RECORD OF DECISION

Proposed Infrastructure Improvements and Rentschler Field Development

East Hartford, Connecticut

JANUARY, 2007

**FIGURE 1
FULL BUILD
MASTER TRANSPORTATION PLAN**

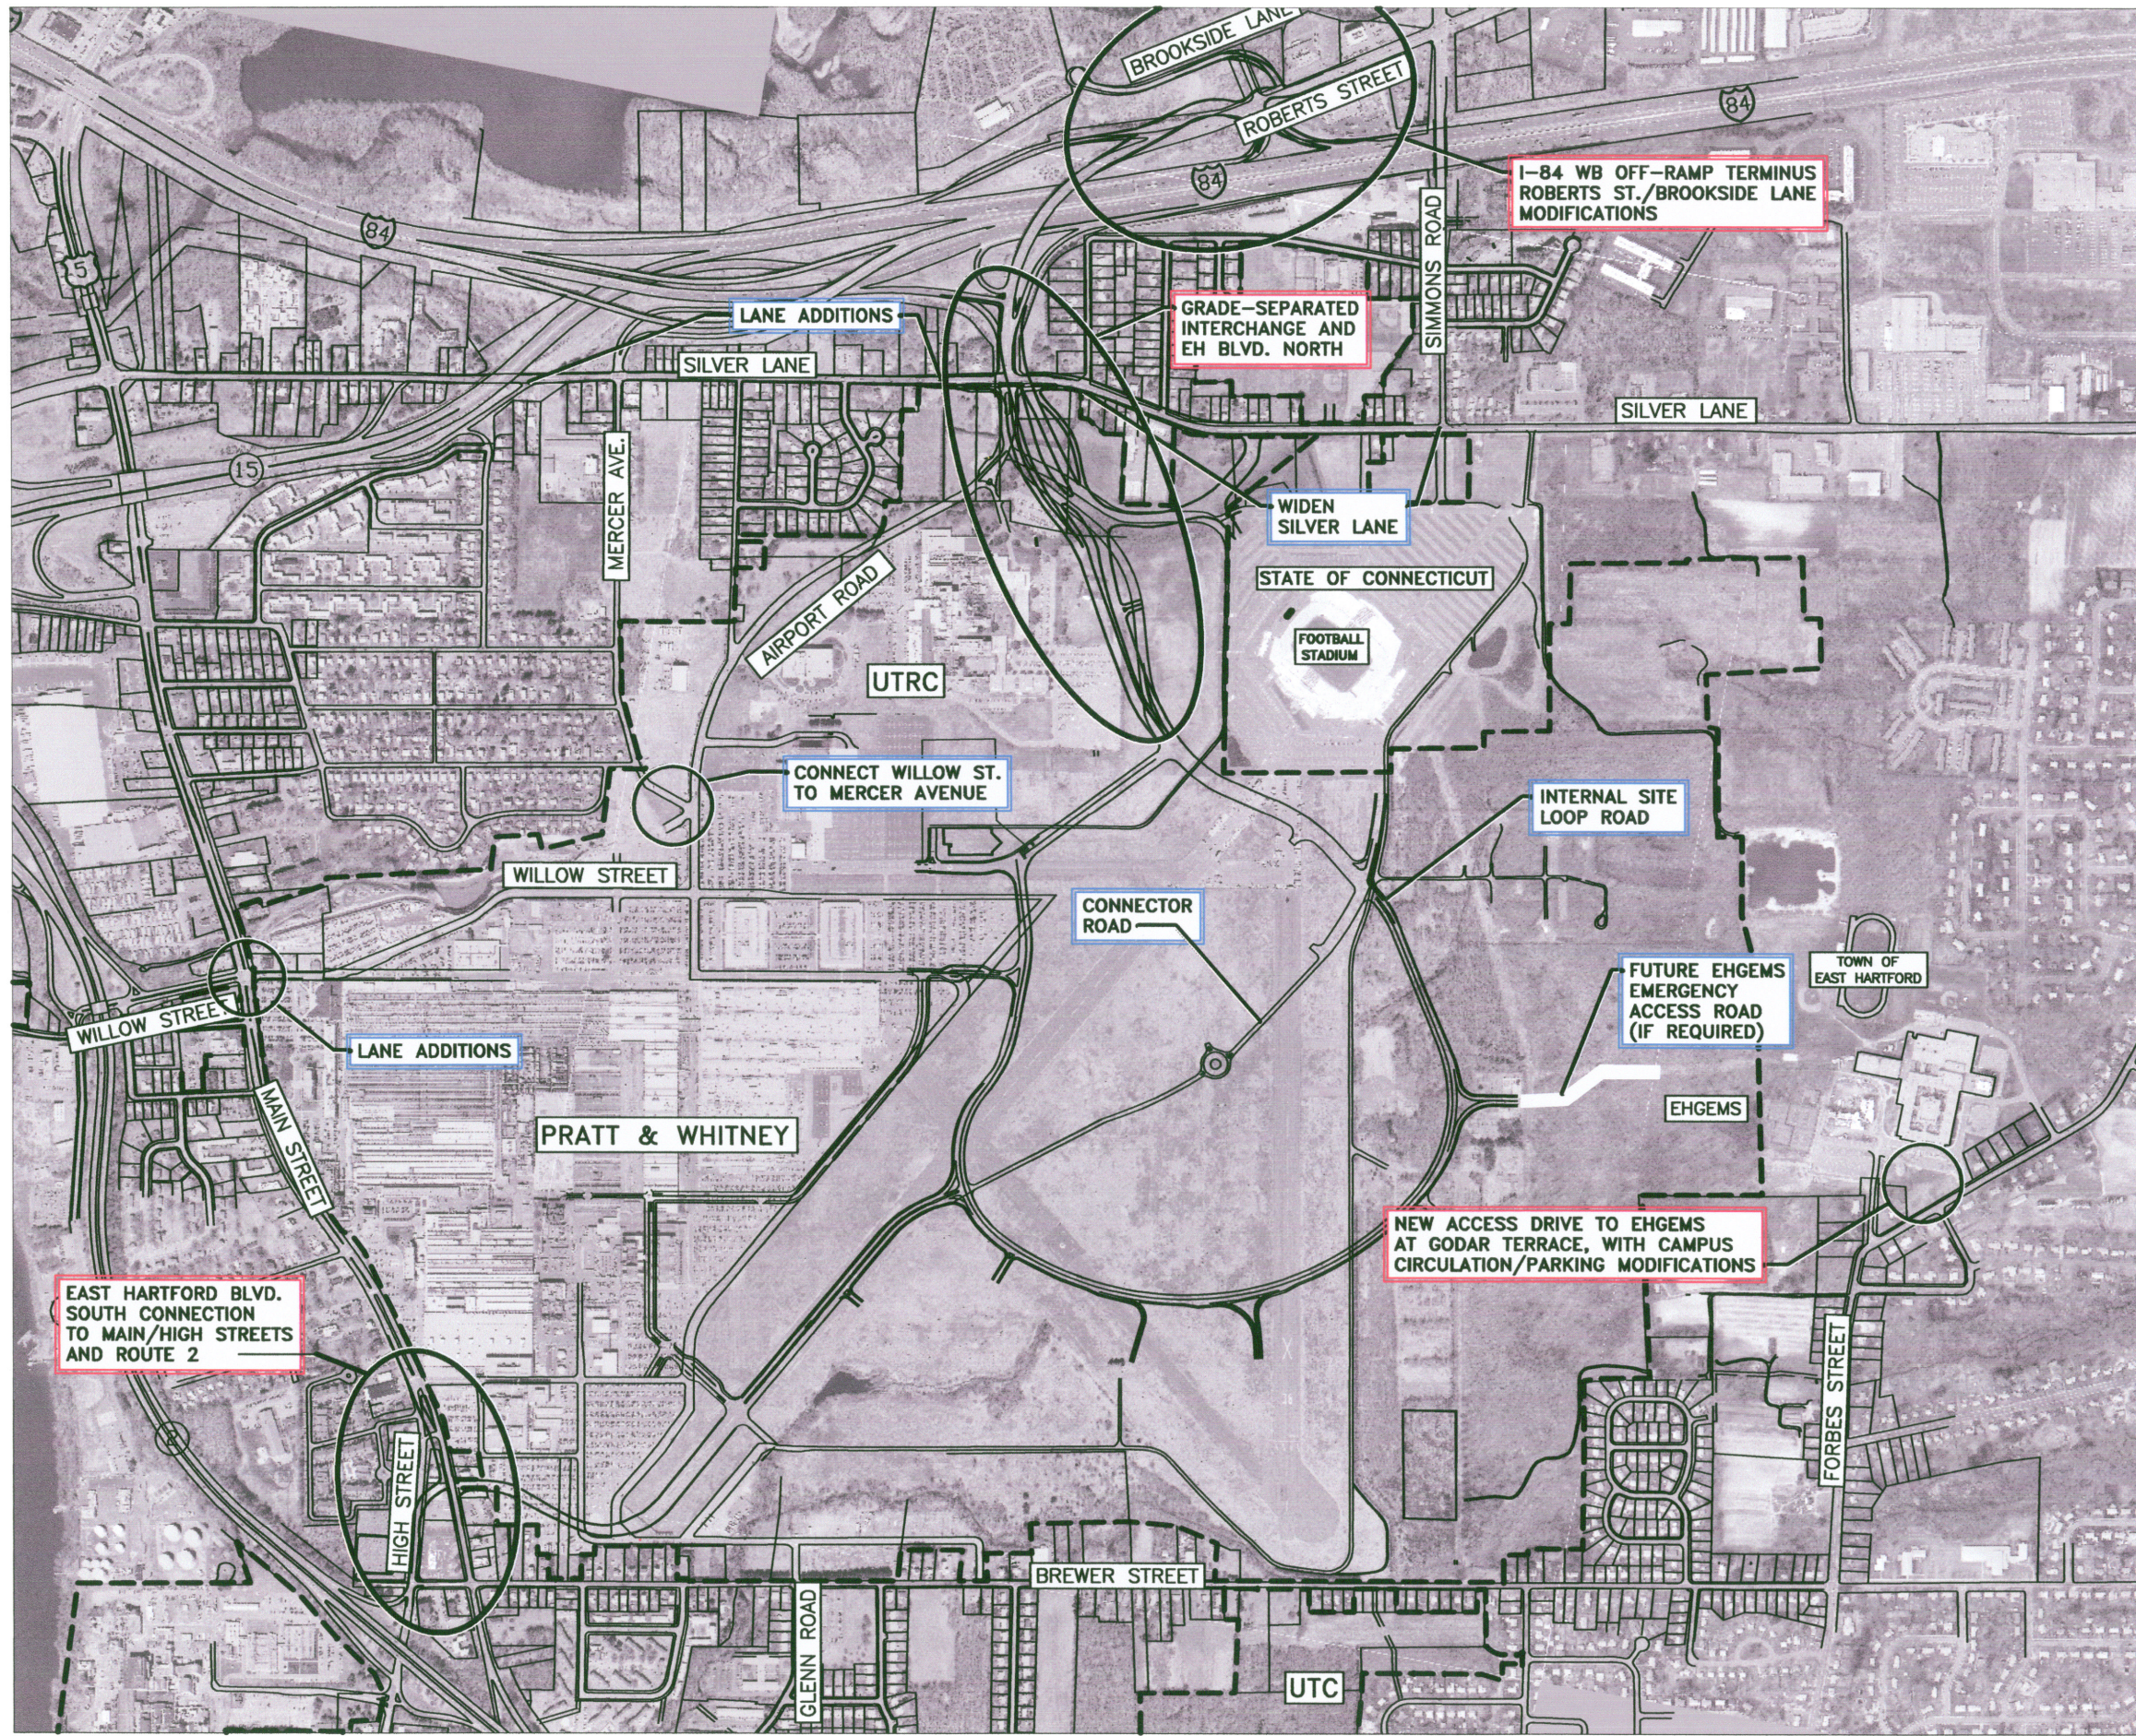
CEQ-5 Comment: *"The completion of the Charter Oak Greenway is buried in this document. It does not appear on the Full Build Master Transportation Plan (Fig. ES-1), nor on the Rentschler Field Master Plan (Fig. ES-4). It is not mentioned in the executive summary. The greenway is*

DOT-1 Comment: *"The mapping shown in Figure ES-1 indicates general roadway improvements for the development as being State funded improvements. This statement appears to contradict Section 14-311 of the Connecticut General Statutes which states that the person or company building, establishing or operating a certified development is responsible for 100 percent of the cost of the improvements needed to handle traffic safely and efficiently."*

CEQ-5 Response: The Charter Oak Greenway is not part of the Proposed Action, however it is recognized as a reasonably foreseeable action and, therefore, has been included in the EIE. Although it does not appear in Figures ES-1 and ES-4, it is shown in Figure 3.3.3-1 and discussed in that section of the document. The proposed Greenway has been discussed during several interagency working group meetings during the CEPA process. In fact, recently, the Matos Group, the Capitol Region Council of Governments (CRCOG) and the Town of East Hartford have met to further discuss potential linkages of the Greenway through Rentschler Field.

**FIGURE 2
 ROADWAY IMPROVEMENTS AT
 SILVER LN, ROBERTS ST, AND E.H. BLVD.**

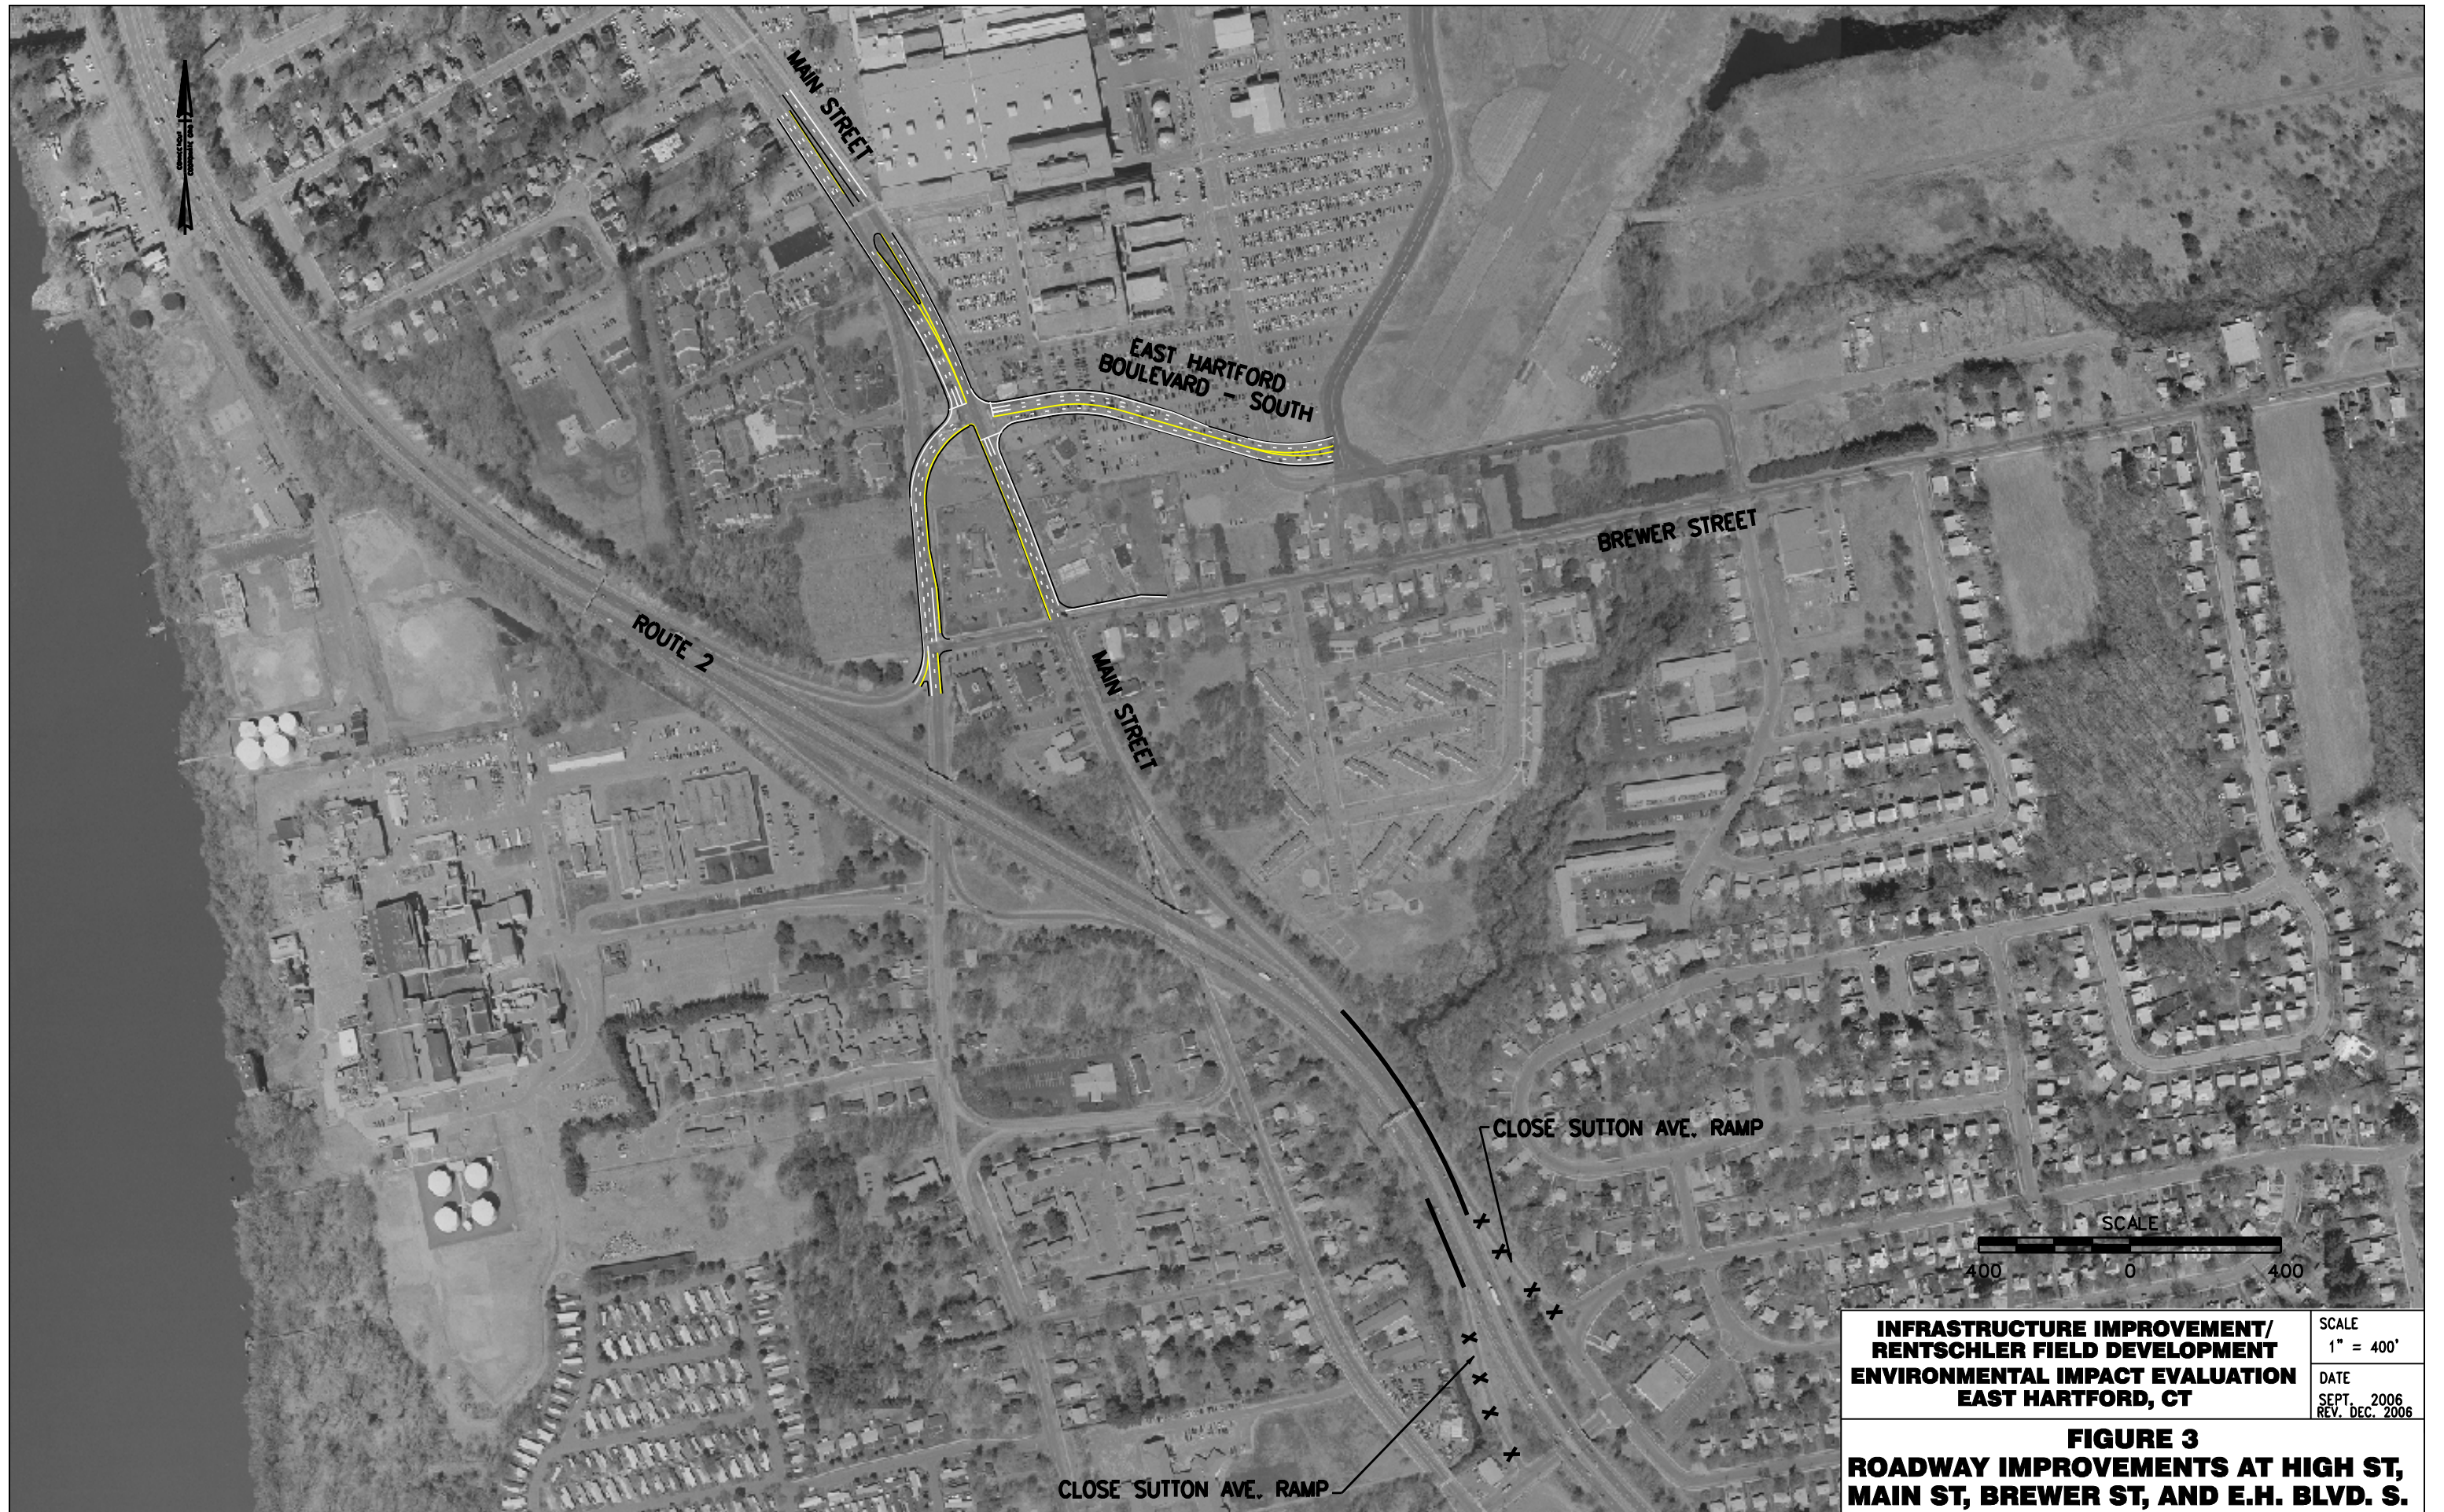
DOT-5 Comment: *"Figure ES-2 does not show any widening on the I-84 eastbound off-ramp to Roberts Street. Previous discussions between the Department of Transportation and the developer's representatives have indicated that a four lane approach is required for the full-build out. It is recommended that widening be indicated on the figure to show two left-turn lanes and two right-turn lanes on the ramp approach. Stop bars on each of the intersection approaches and a break in the painted median on Roberts Street should be shown since the intersection will operate under traffic signal control."*

DOT-7 Comment: *"Access from Silver Lane to the Pratt & Whitney facility via Airport Road is to be eliminated. It is recommended that a cul-de-sac on Airport Road be shown on Figure ES-2."*

DOT-3 Response: The I-84 EB on ramp is shown to have two lanes leaving Roberts Street then merging to one. (See Figure 2). As discussed in several meetings during the CEPA process, metering of the ramp may be needed to accommodate future development and to prevent mainline I-84 operational failures. This will be evaluated in greater detail during the design process.

DOT-5 Response: The figure has been revised to show 4 lanes for the I-84 eastbound off ramp approaching Roberts Street. The center lane striping on Roberts has been revised and STOP bars added as shown in Figure 2.

DOT-6 Response: A STOP bar for the westbound approach of the relocated Roberts Street at East Hartford Boulevard North has been added as shown in Figure 2.

DOT-7 Response: The north end of Airport Road will be a cul-de-sac as shown in Figure 2 in this document.
